# CABINET MEMBER FOR HIGHWAY MANAGEMENT – 17 NOVEMBER 2022

**BLADON: PROPOSED 20MPH SPEED LIMITS**

Report by Corporate Director, Environment and Place

Annexes Annex 1: Consultation plan

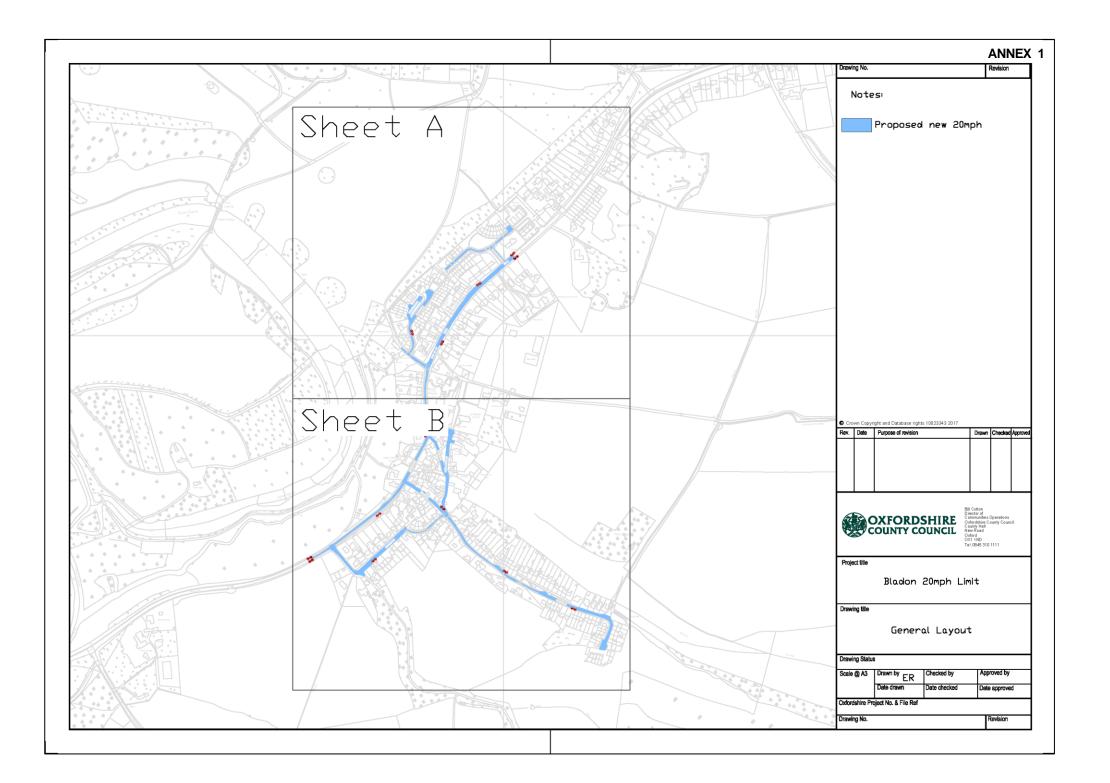
The proposed TRO states 20mph is from a point 26 metres northeast of its junction with Home Farm Close, the fixed camera is approx.68 metres northeast of junction with Home Farm Close.

If this is correct, I suggest housing will need to be removed as change of speed limit, 30mph to 20mph, will be in middle of the secondary check marks. This would be confusing for drivers and likely draw complaints.
